Sub: Corrigendum-01: Amendment to Tender specification document & due date extension

- 1. E-Tender specification No: 2101094
- 2. **Scope of work:** Detailed drawing preparation based on Input design drawings provided by BHEL-Engineering Centers for Flue Gas Desulphurization (FGD) Package as specified in scope and getting approval from BHEL- Engineering Centers/ NTPC. Fabrication and supply of finished product (procurement of raw structural steel will be in the scope of bidder) i.e. structures of FGD as per BOM/Drawings at 2X500 MW NTPC Mauda, Stage-I, TPP-FGD, Maharashtra.

2 X 500 MW MAUDA STPP-FGD PACKAGE			
DWG / DOC NO AND TITLE : 9561-109-ISG-PVC-B-445 - CONVEYOR LBC-1AB-GA OF GALLERY & TRESTLES R0				
SL NO	NTPC COMMENTS	BHEL REPLY		
1	Hold	Staad file has been revised and errors resolved		
2	PTFE bearing shall be provided for slinding support	Accepted. PTFE indicated in elevation view.		
3	COMPLY TO COMMENTS MARKED DESIGN DOCUMENT	Complied		
4	DESIGN/DRAWING TO CONFORM TO LATEST MECHANICAL/ELECTRICAL GADRG.	Accepted. Trestle Tr-2A introduced for structural requirement, after discussion with mechanical. The same will be updated in Mech GA dwg.		
5	ALL FURTHER CHANGES TO BE I

FOR 9561-109-PEM-PVC-B-077 R0 NTPC COMMENTS RECEIVED VIDE LETTER Reference: CC:PE:9561:109:39665 DATED 02.12.2019

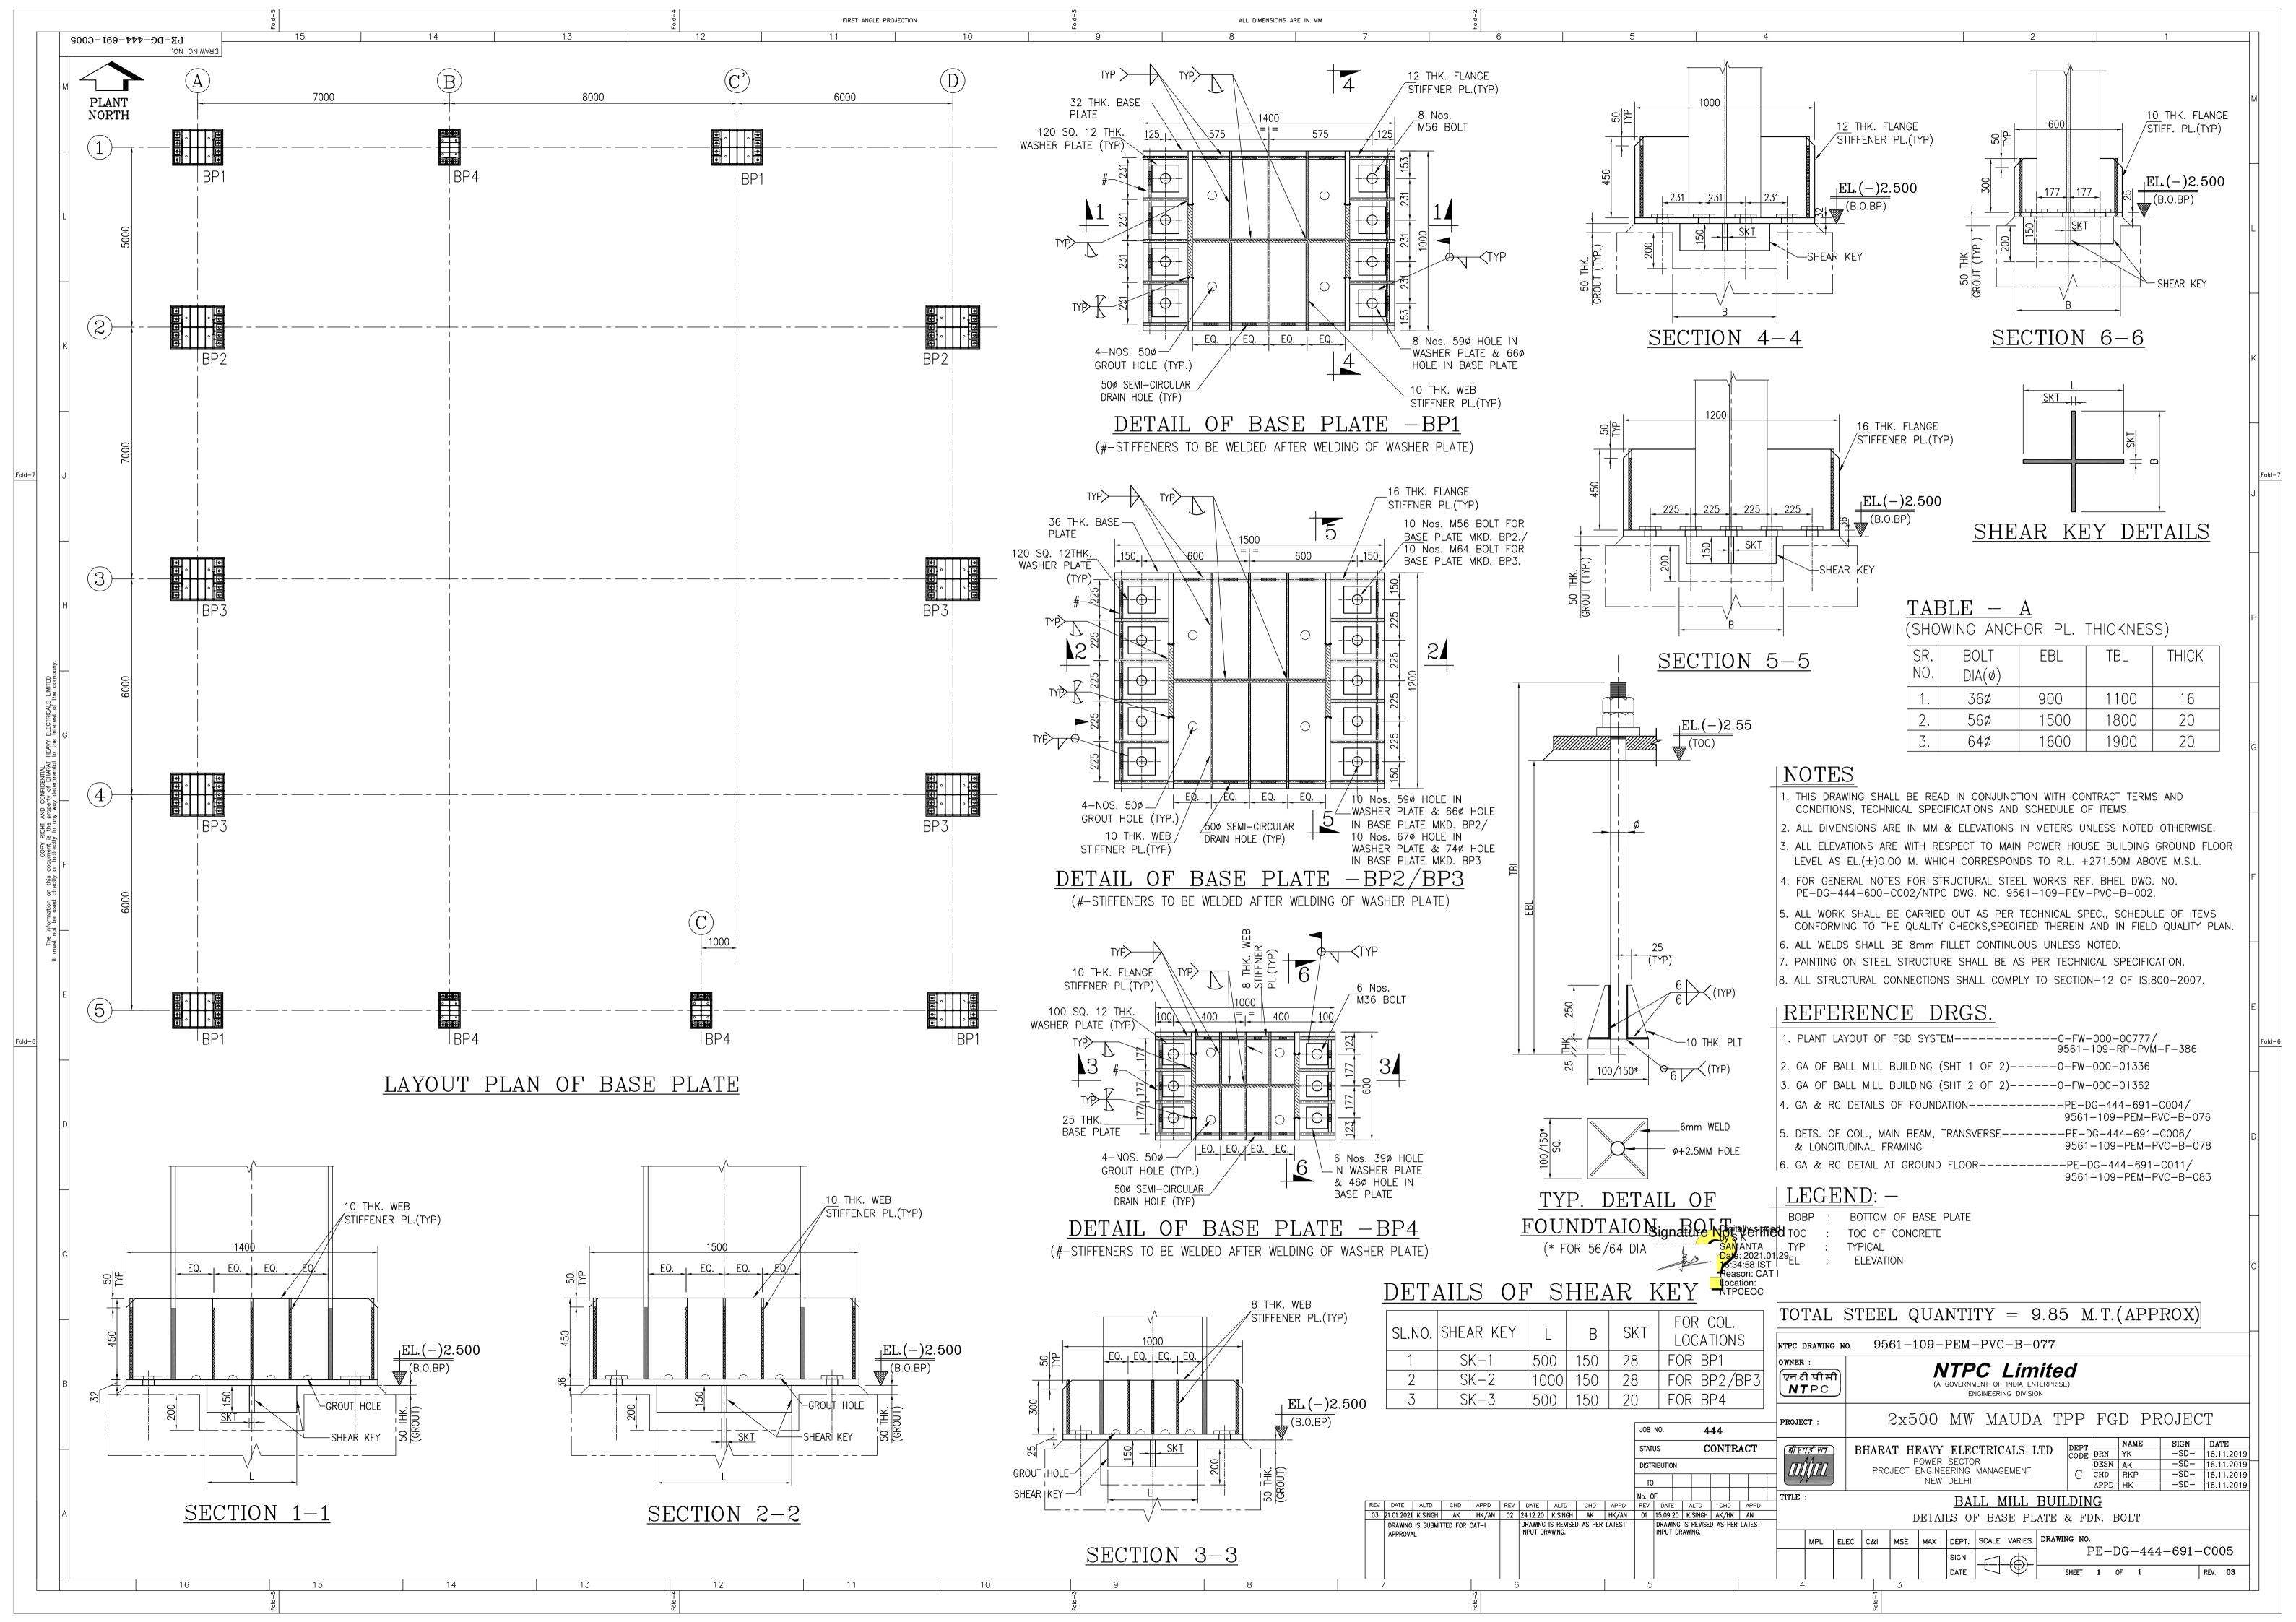
SL NO	NTPC COMMENT	BHEL REPLY
1	Load calculation & Analysis of Ball Mill	Load calculation & Analysis of Ball
	Building is yet to be submitted for	Mill Building revised and submitted
	NTPC approval. This document	separately.
	document can be reviewed after	Kindly refer doc. No. 9561-109-
	approval of Load calculation &	PEM-PVC-U-176-00.
	Analysis of Ball Mill Building and	
	Design of Foundation.

FOR 9561-109-PEM-PVC-B-077 R2 NTPC COMMENTS RECEIVED VIDE LETTER Reference: CC:PE:9561:109:40506 DATED 11.01.2021

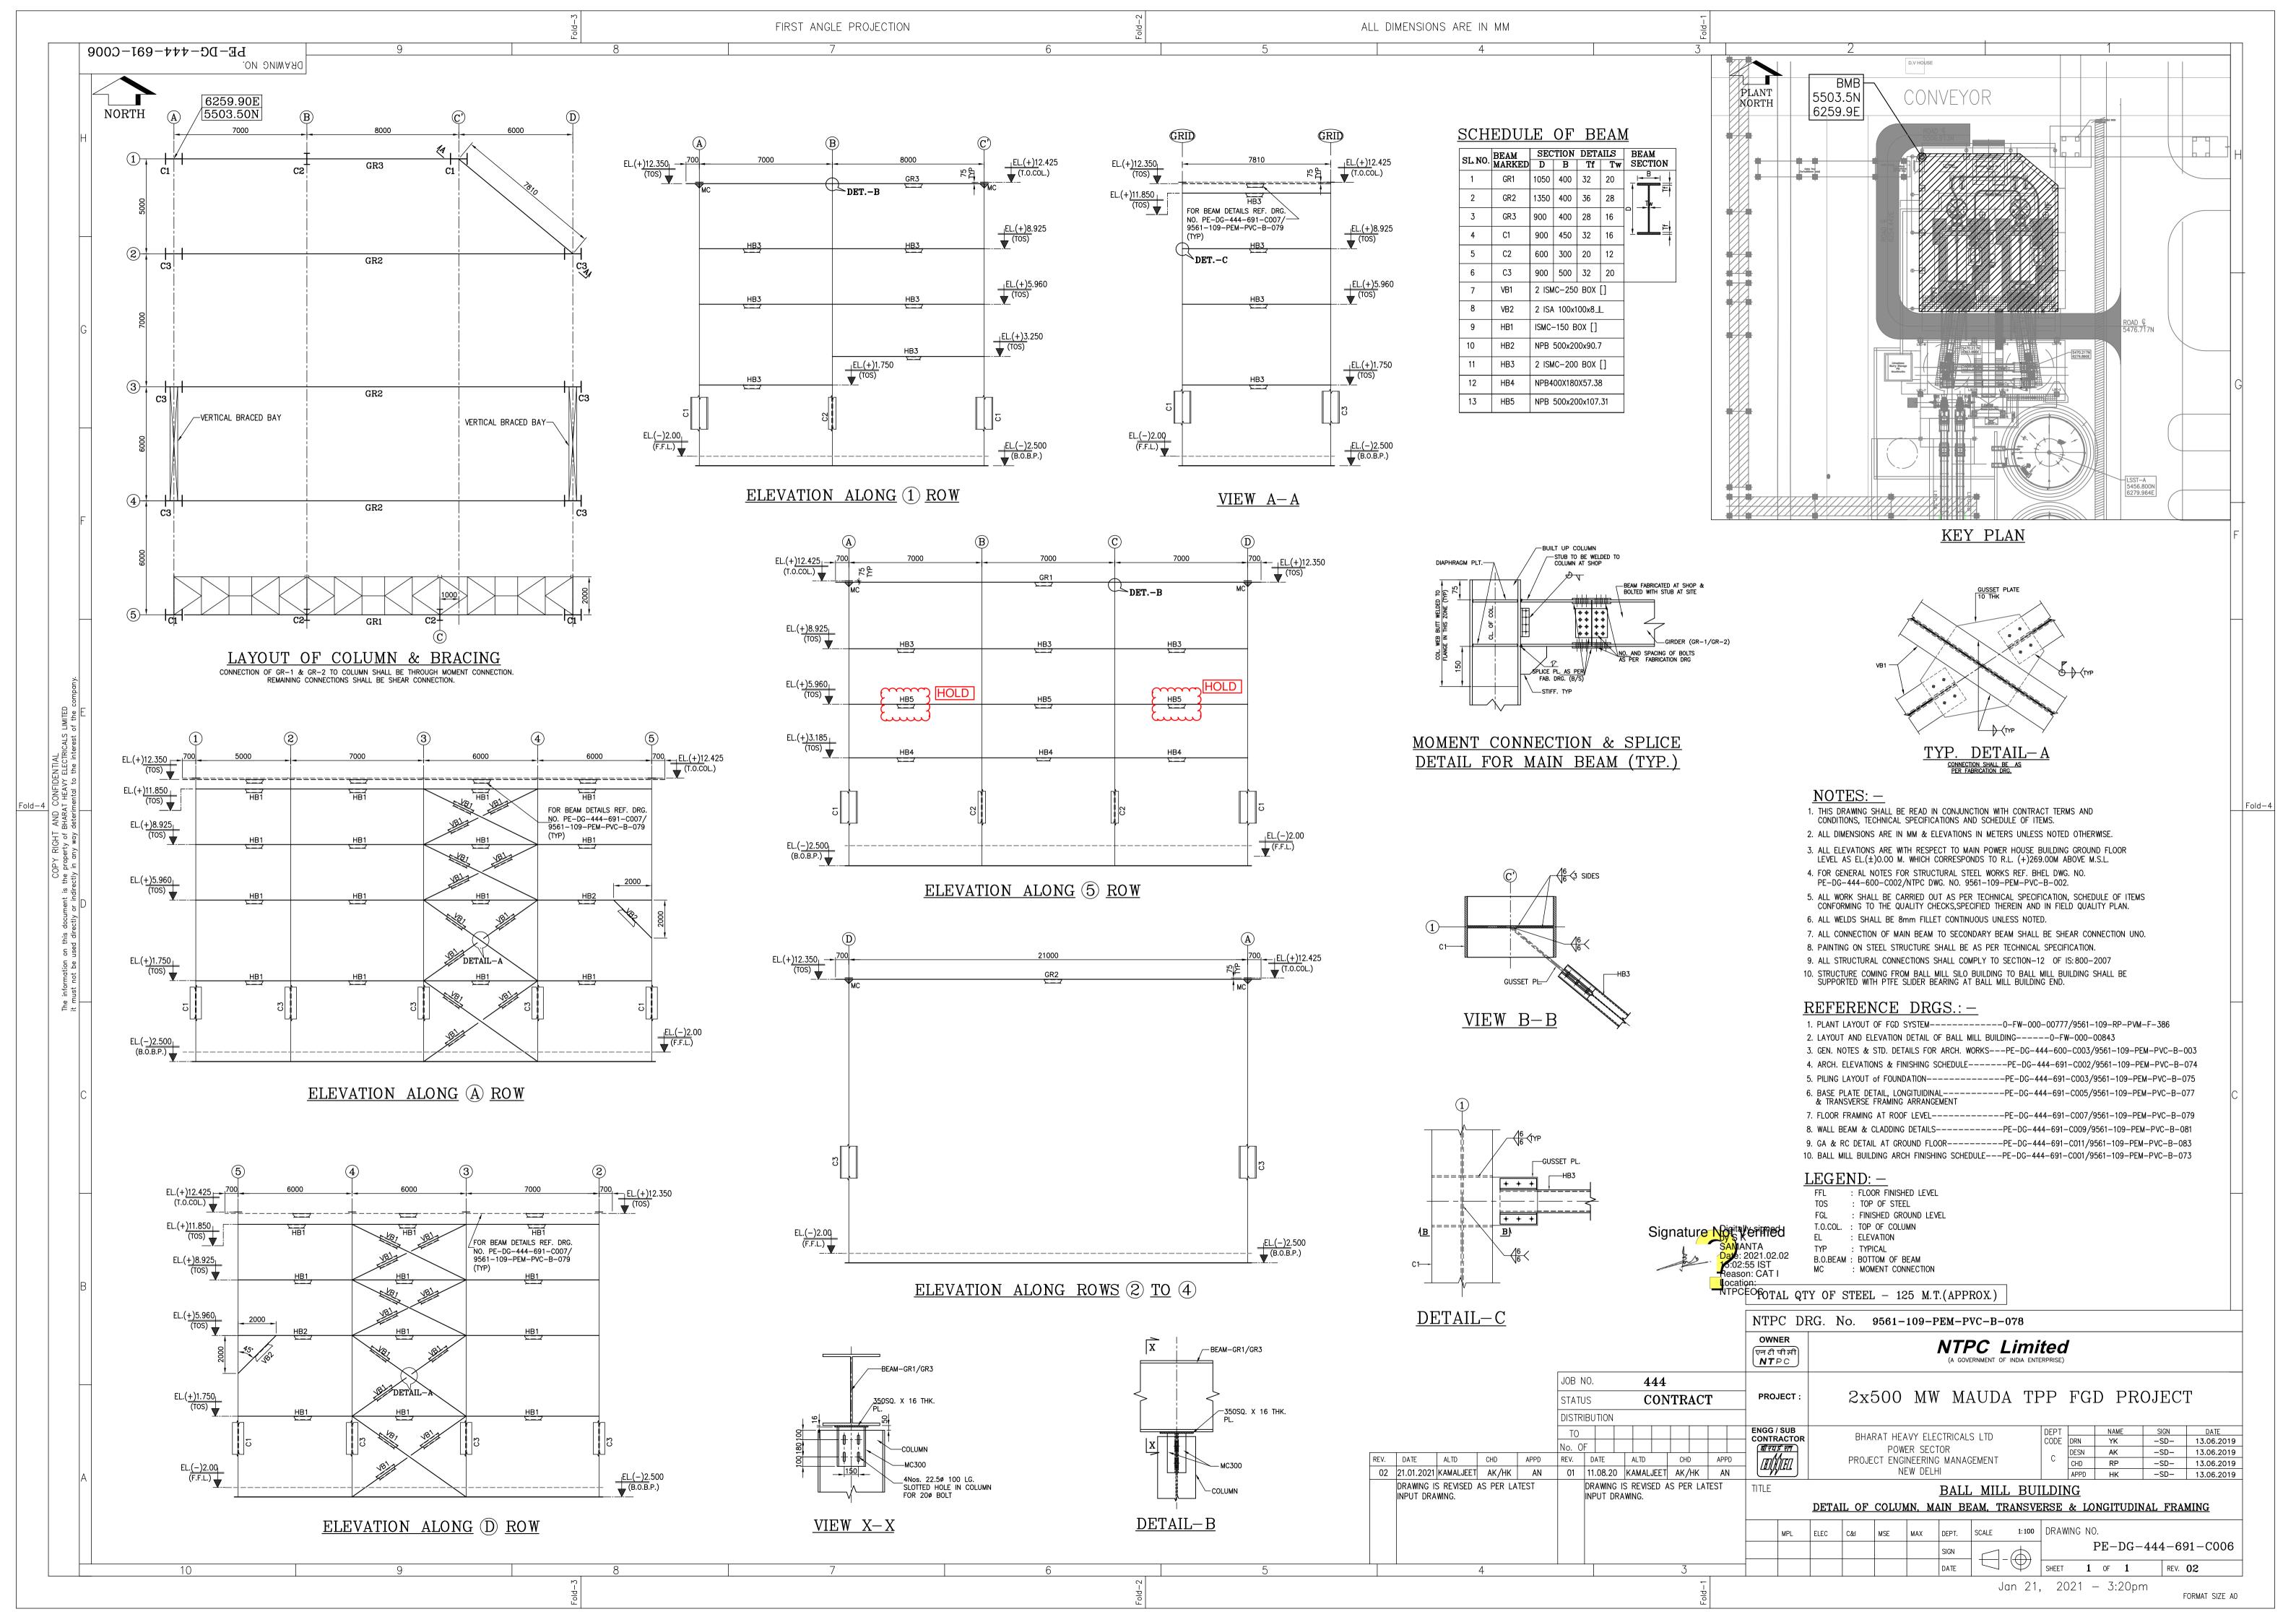
SL NO	NTPC COMMENT	BHEL REPLY
1	Review in line with the comments	Drawing reviewed and found in
	marked on design document.	order.
